Vogtle Nuclear Plant Excavation
Proposal for dewatering test well program

To	Files	Date	May 10, 1972
Subject	Investigation for Dewatering of Plant Excavation, Vogtle Nuclear Plant Job No. 9510-001	From	C. R. Farrell
		Of	Geology
Copies to	W. Holland A. Luft C. McClure W. Ferris	At	E & I Division

DEWATERING STUDY

ALVIN W. VOGTLE NUCLEAR PLANT GEORGIA POWER COMPANY

Figure 3

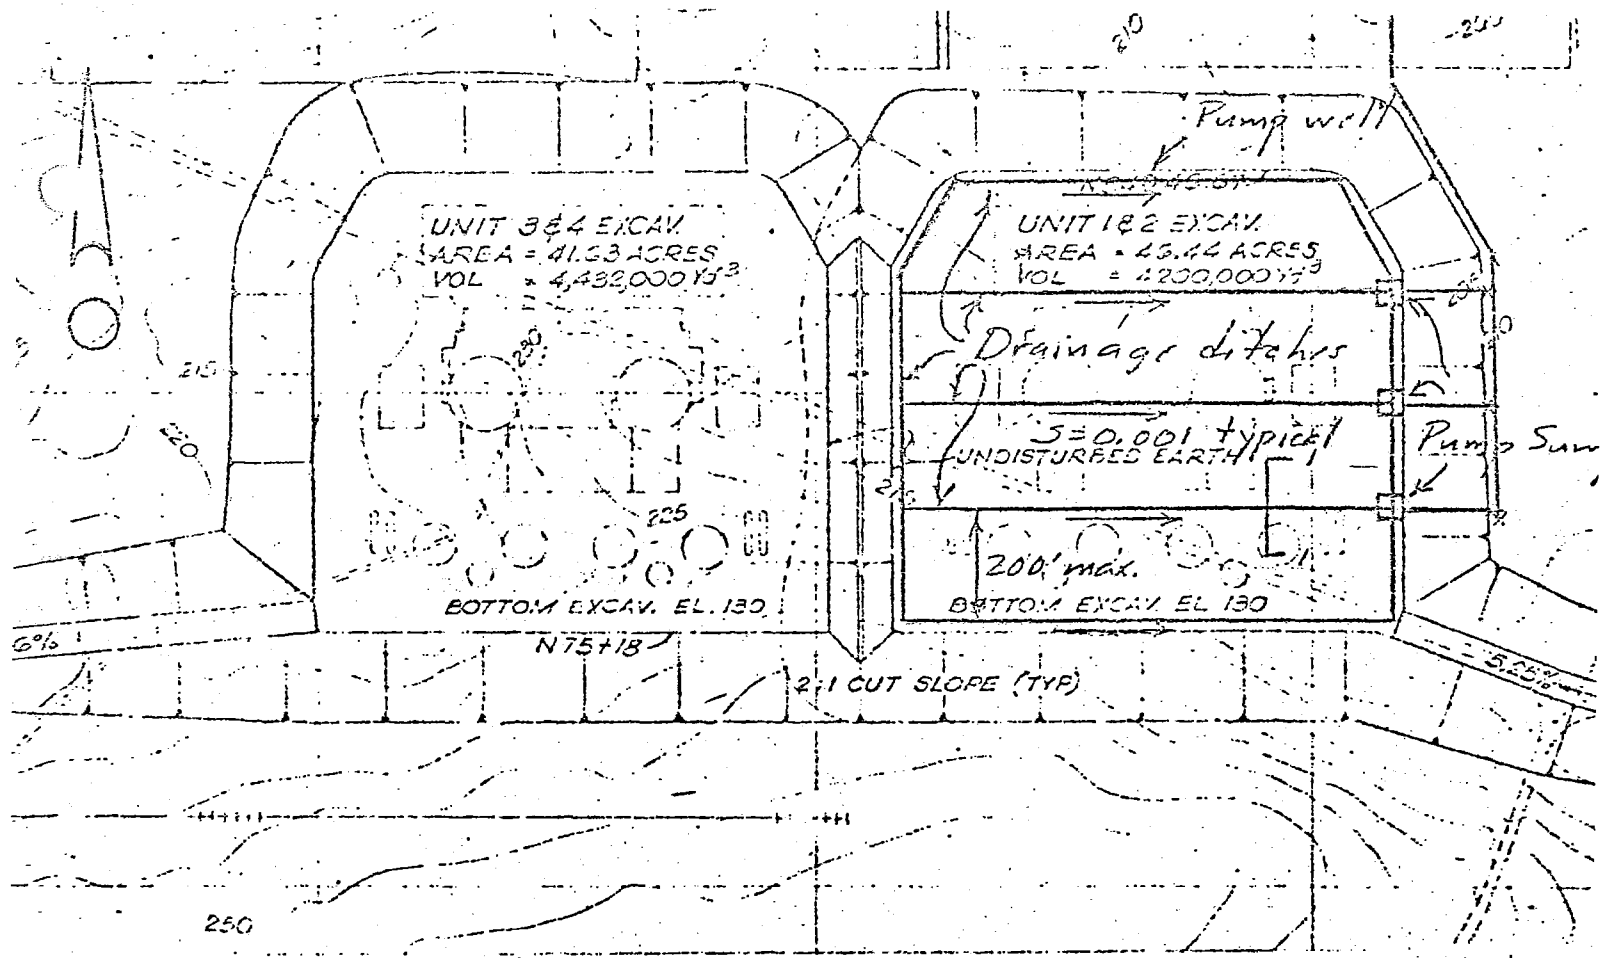
Stage I

1. Install discharge pipe. Size of line to be based on maximum design rate of pumping to handle storm water.
2. Excavate with scraper equipment down to about 3'± above water table.
3. Excavate drainage-dewatering ditches with Grapple or backhoe. Maximum spacing between ditches to be 400'. Provide initial pumping capacity of 1500 gpm minimum. Final pumping rate for dewatering estimated at 300 gpm.

Figure 4

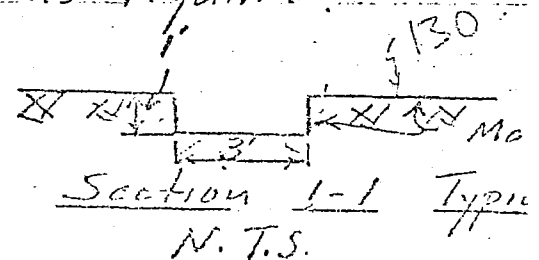
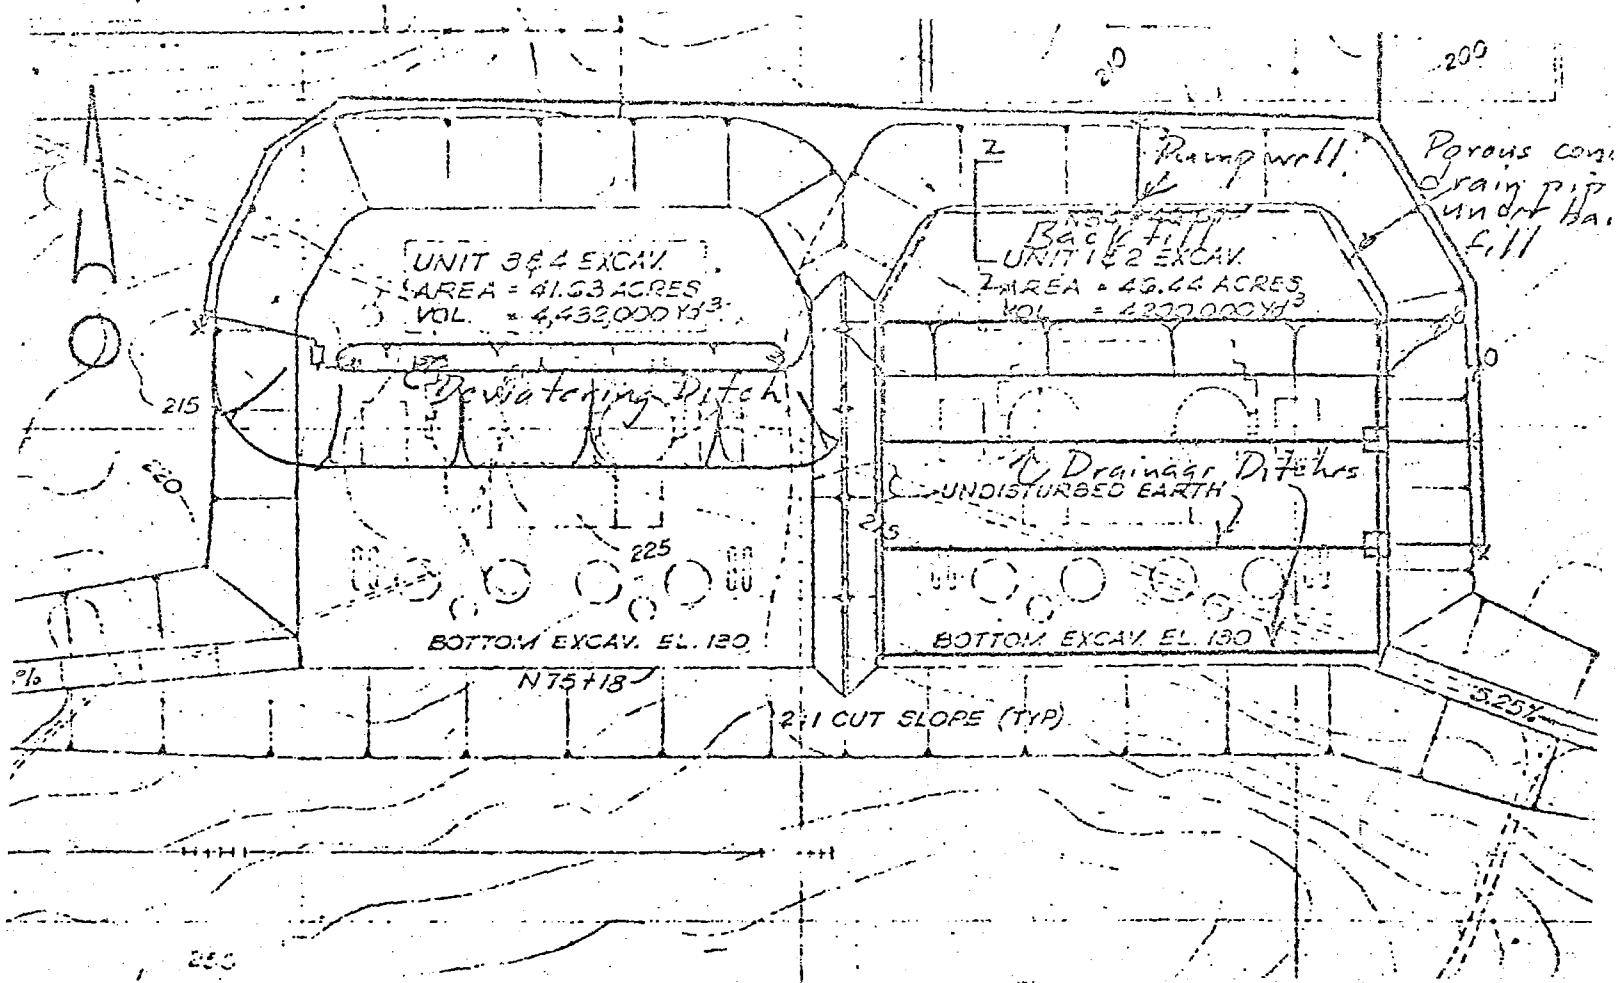
Stage II

1. After completion of excavation to subgrade, cut storm water drainage ditches in marl as indicated. Install storm water pumps.
2. Prior to starting backfill, install porous concrete drain pipe around perimeter in a properly graded filter envelope to allow dewatering during period of backfilling up to water table. Install pump well in backfill.
3. Provide appropriate ditches in backfilled areas to allow drainage of storm water as required.

Figure 5

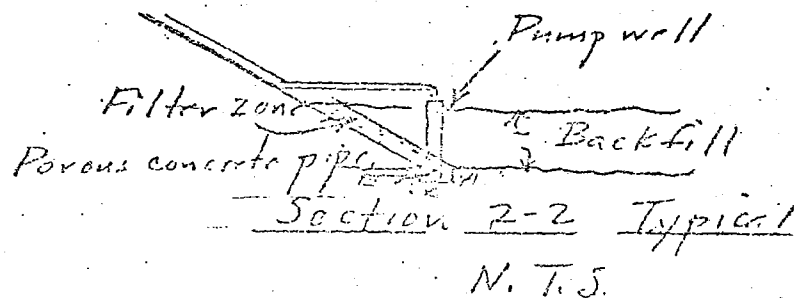
Stage III (Phase III Excavation, Drwg. SK-C-5C)

1. Dewatering in Units 1 & 2 Turbine Bldg. by perimeter drain during backfill.
2. Install additional discharge piping to Units 3 & 4 area. Dewatering by ditching similar to Stage I.
3. Provide storm water pumping equipment in areas as required.

Figure 6

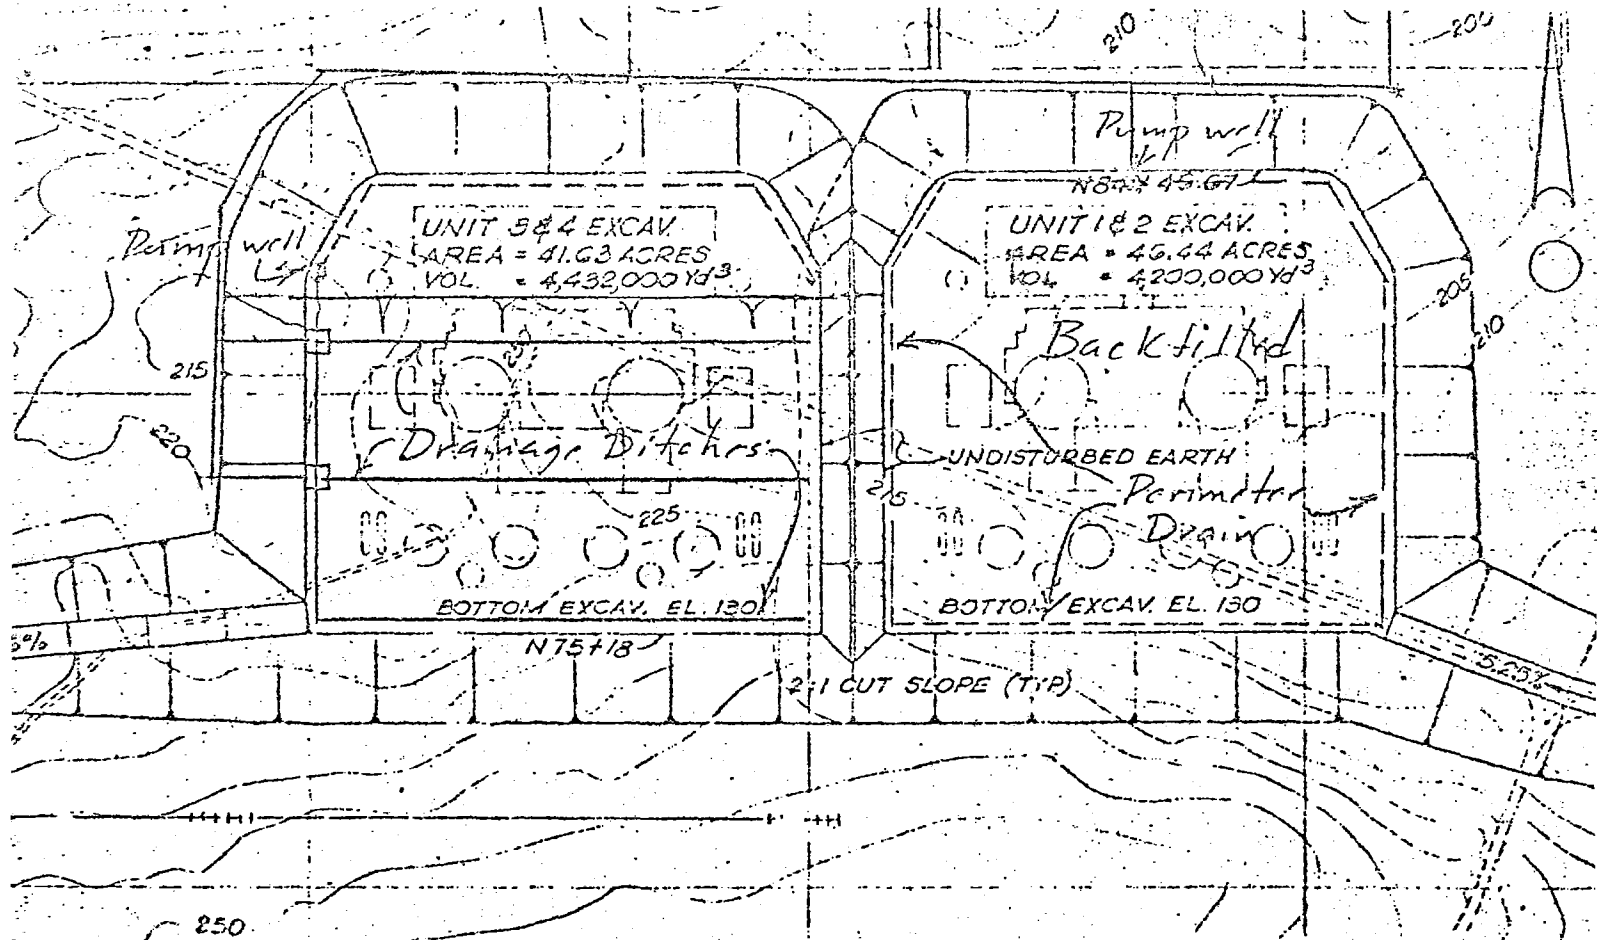
Stage IV (Phase IV) Excavation, Drwg. SK-C-51)

1. Continue pumping on perimeter drain in Unit 1 & 2 area as required to (a) permit backfilling in "the dry", (b) control hydrostatic uplift under partially completed structures, and (c) control seepage from east for completion of construction of Units 3 and 4.
2. Install additional discharge piping to south portion of Units 3 and 4 area. Dewater by ditching similar to Stage I.
3. Excavate ditches in marl for handling storm water similar to Stage II.
4. Install perimeter drain around north, west, and south sides of Unit 3 and 4 area. Complete construction.
